CLAREMONT BUSINESS PARK 2 FIL. NO. 1 - LOT 5

EL PASO COUNTY, STATE OF COLORADO
GRADING & EROSION CONTROL PLAN

EPC STORMWATER REVIEW COMMENTS
IN ORANGE BOXES WITH BLACK TEXT

GRADING & EROSION CONTROL PLAN
CLAREMONT BUSINESS PARK 2 FIL. NO. 1 – LOT 5
JOB NO. 44-037
DATE PREPARED: JULY 17, 2020
DATE REVISED: SEPT 4, 2020

SHEET 2 OF 3

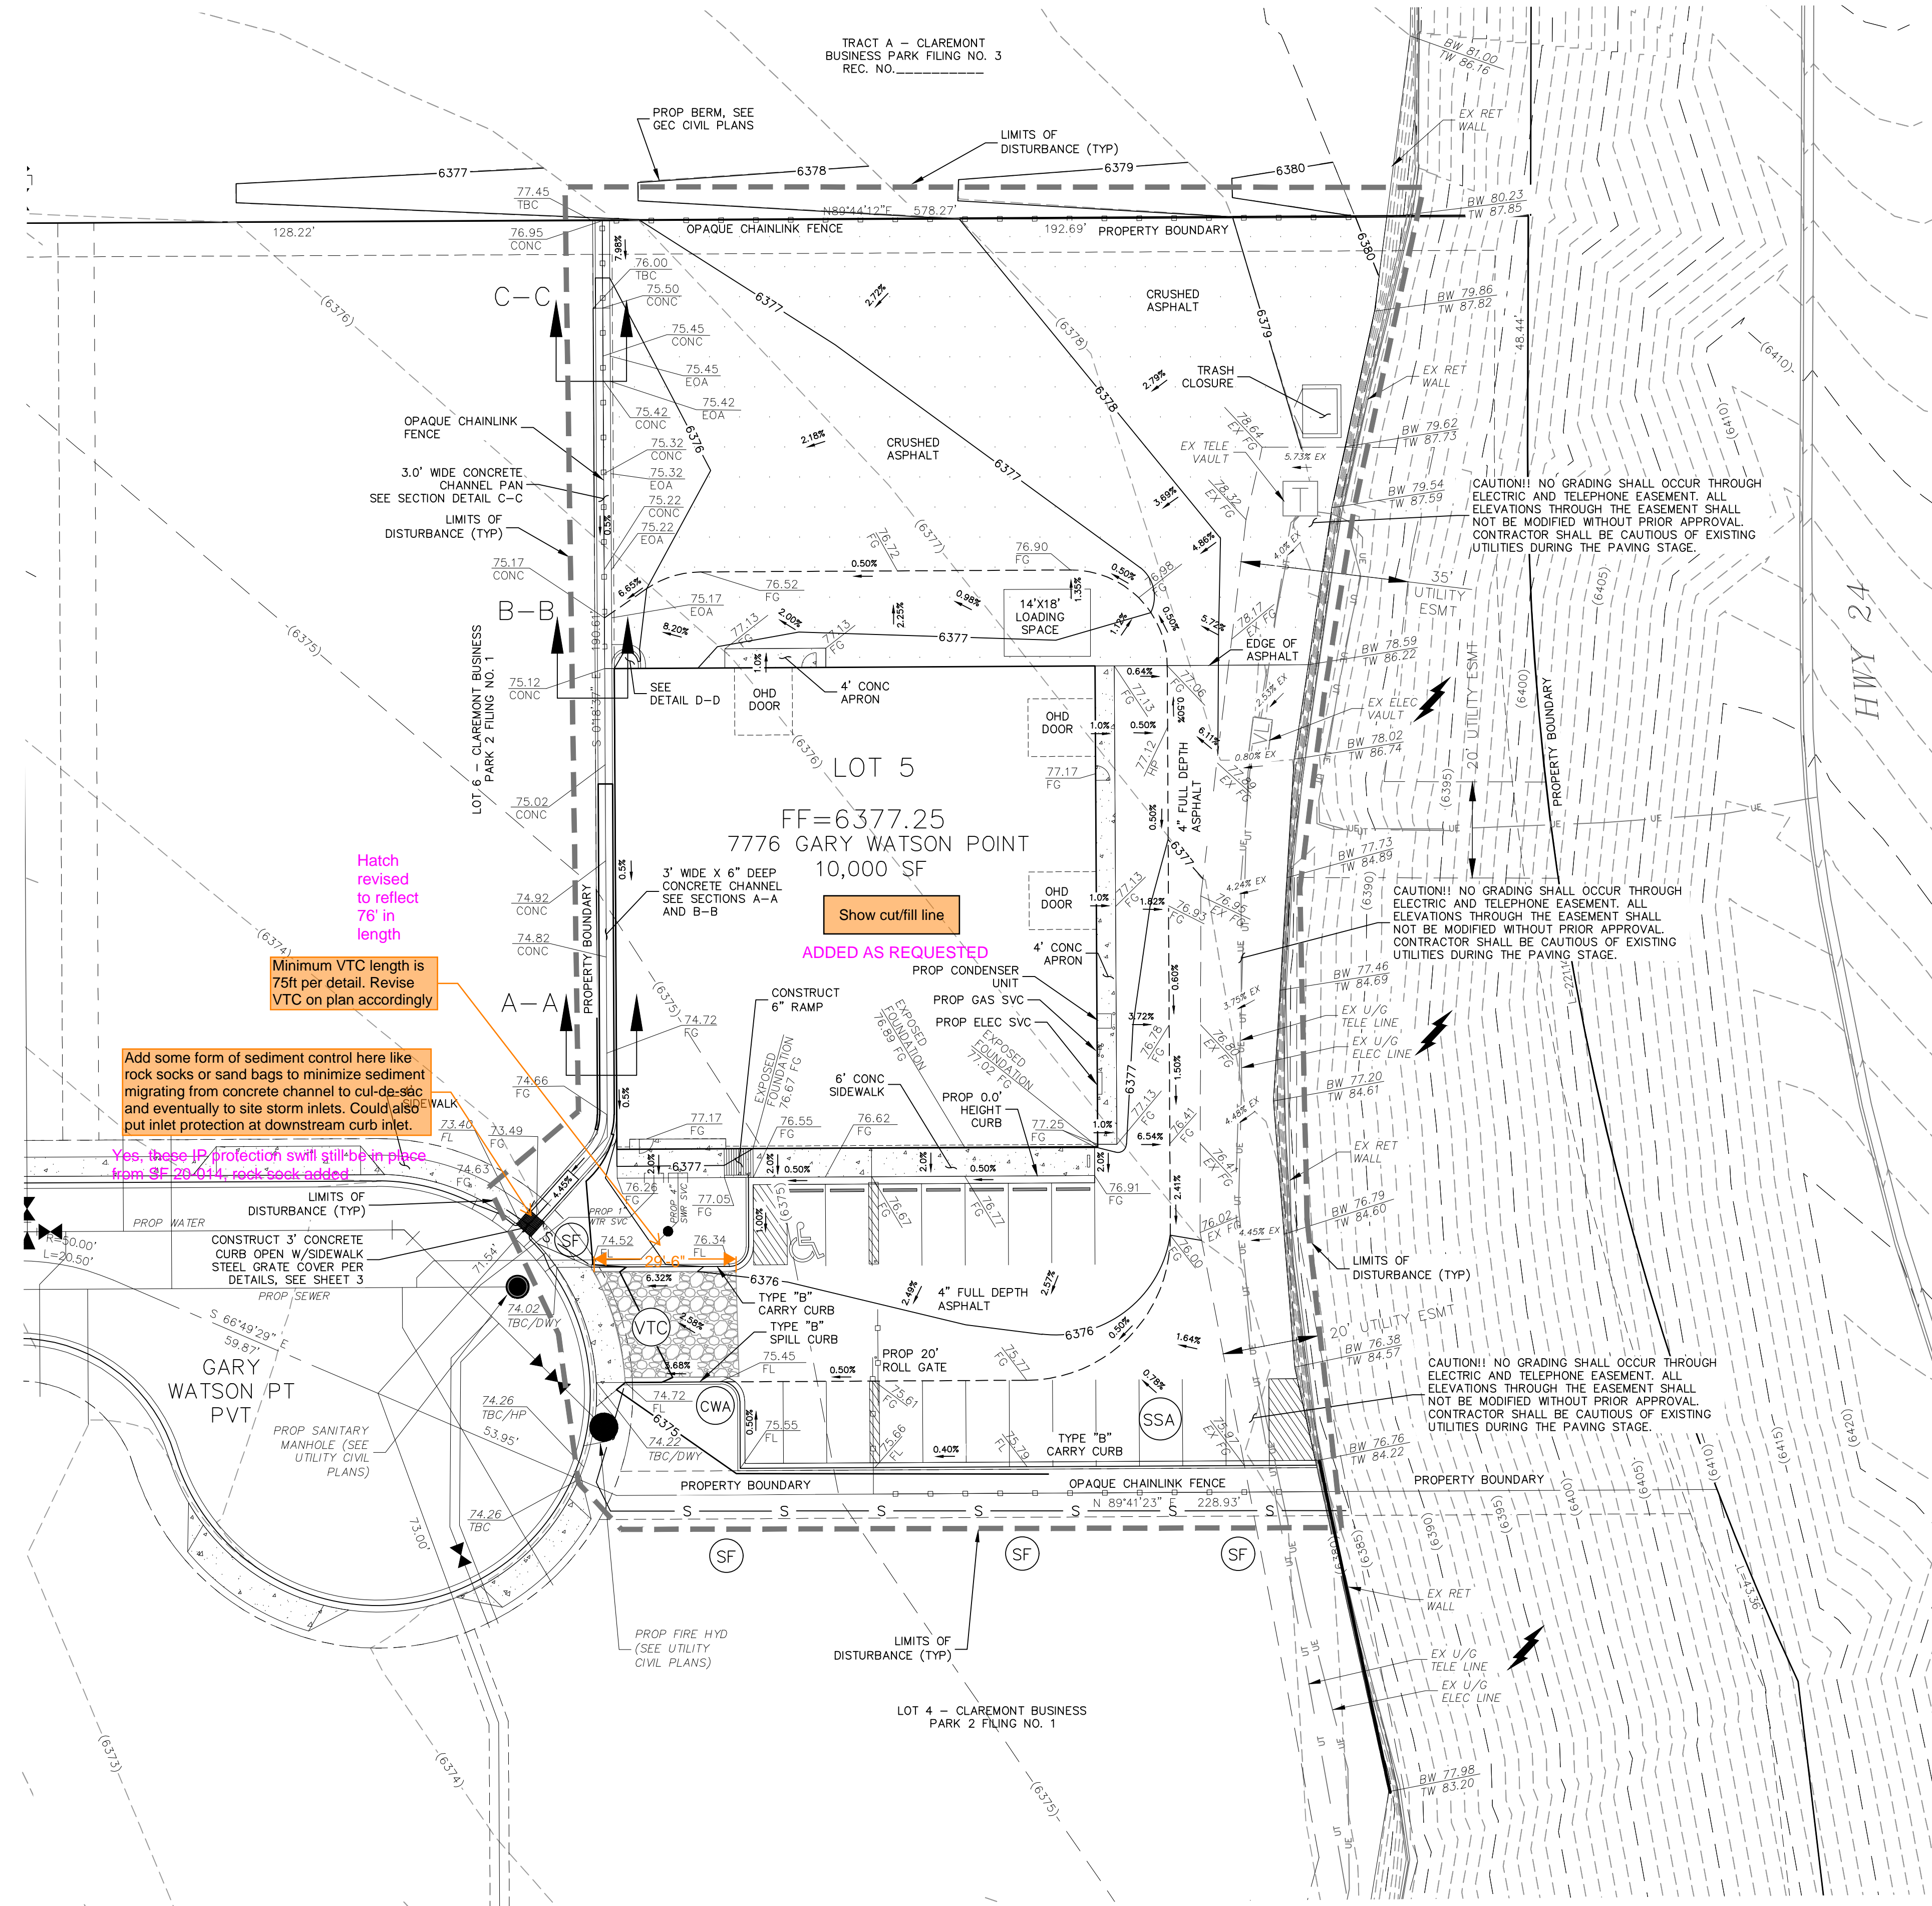
Item I: include note about condition and type of existing vegetation (

If same as Construction Boundaries, revise label to say:
 "Limits of Disturbance / Construction"

Add the following items to the Legend: - Drainage flow arrows - cut/fill line

Hatch areas to receive permanent seed/mulch and/or add a note stating the criteria for when/how/where seeding will be done (example: disturbed areas not being landscaped).

Noted added as requested

CONSTRUCTION ADDED, ITS ONE IN THE SAME

ADDED AS REQUESTED

NOTES ADDED. LANDSCAPE PLANS ARE A PART OF THIS SUBMITTAL. SEEDING AREAS ARE SHOW THEREIN
